MILITARY SPECIFICATION

CONNECTOR, OXYGEN MASK TO REGULATOR CRU-60/F

This amendment forms a part of Military Specification MIL-C-38271A, dated 11 March 1968 and is approved for use by the Department of the Air Force and is available for use by all Departments and Agencies of the Department of Defense.

FIGURE 6 MASK PORT

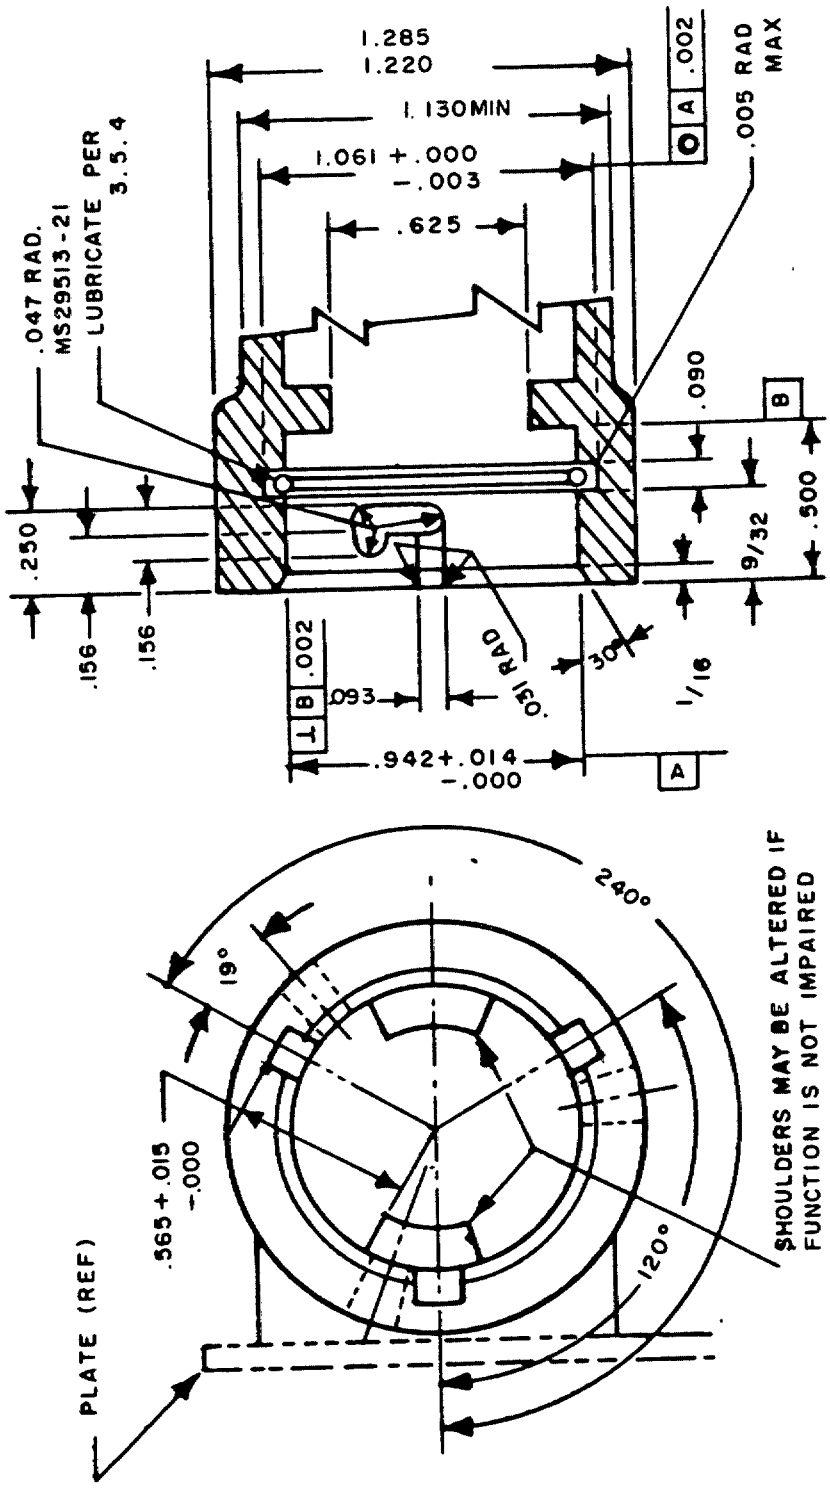
*Figure 6: Delete and substitute Figure 6 as shown on Page 3 of this amendment.

EDGES AND FILLETS RADII .010 UNLESS OTHERWISE SPECIFIED.

THE MASK PORT SHALL MATE PROPERLY WITH MS27796.

"O" RING GROOVE FINISH:
SIDES 63 MACHINE FINISH
BOTTOM 32 PER ASA B46.1
